Technical Note TN-SYS004
**STA6682-4H T2000 Multi-Control
Head Microphone Audio Level
Modification**

7 September 2001

This technical note TN-SYS004 applies to all STA6682-4H (PCB IPN 220-01680-01A) T2000 Multi-Control Heads (Master and Slave) delivered before 31/07/2001. All STA6682-4H Control Heads shipped after this date have been modified.

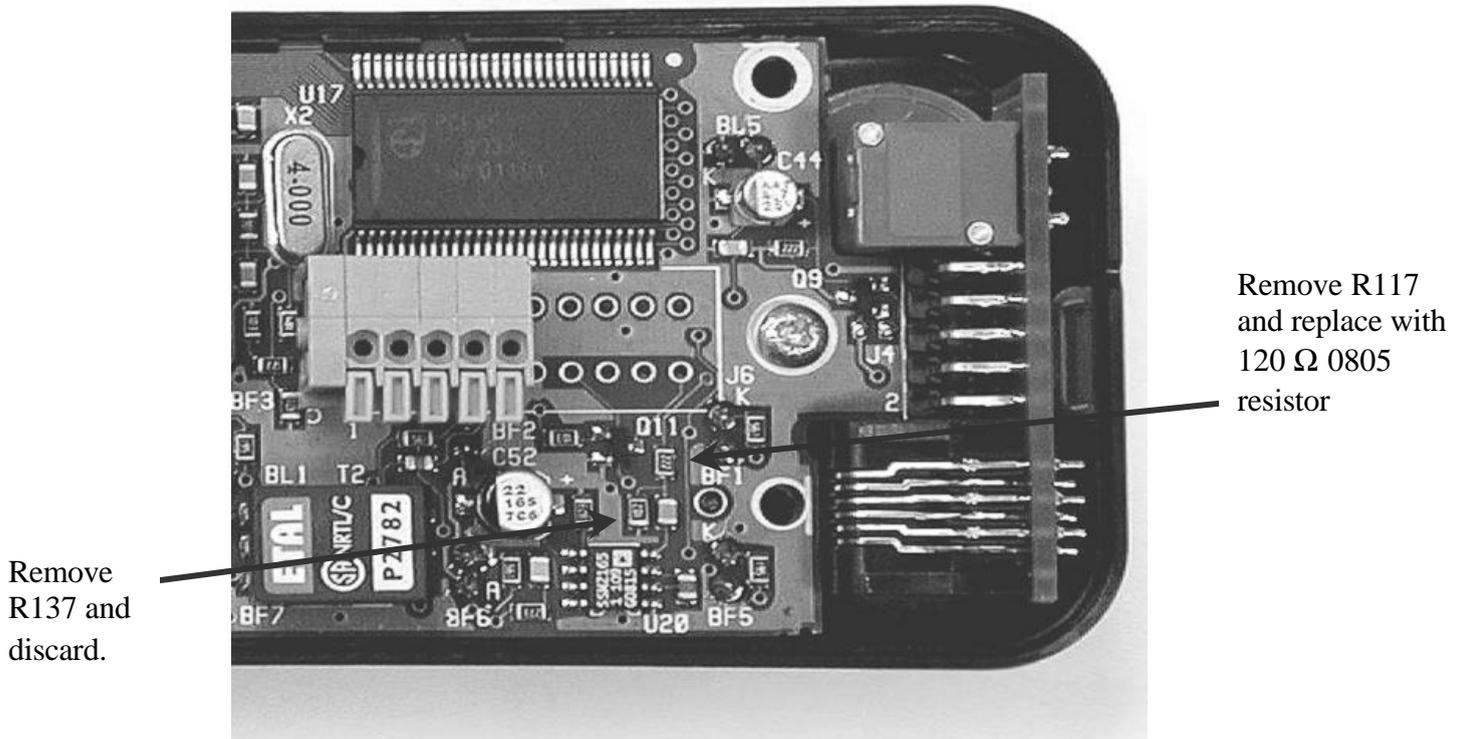
Some users have found the microphone sensitivity insufficient when operating T2000 radio's from STA6682-4H Multi-Control heads. The following circuit value changes increase the microphone audio level to match that of a standard T2000. Note that the advantage of increased background noise immunity is still retained.

Component	IPN	Description	Quantity
1200 resistor	036-13120-00	0805 SMD resistor	1

1. Unplug power supply leads, speaker leads, and microphone hook switch lead from the green connector block mounted on the back of the head.
2. Remove the plate cover and unplug the 8 way micromatch lead.
3. Remove the 4 screws holding the rear panel on to the head. Remove the rear cover. Ensure the two captive bracket mounting square nuts in are not misplaced.
4. Referring to figure 1, remove R117 (2k20) and R137 (1k00).
5. Replace R117 with a 1200 0805 Chip Resistor (as above).
6. Reassemble the head, ensuring the captive square nuts are fitted.
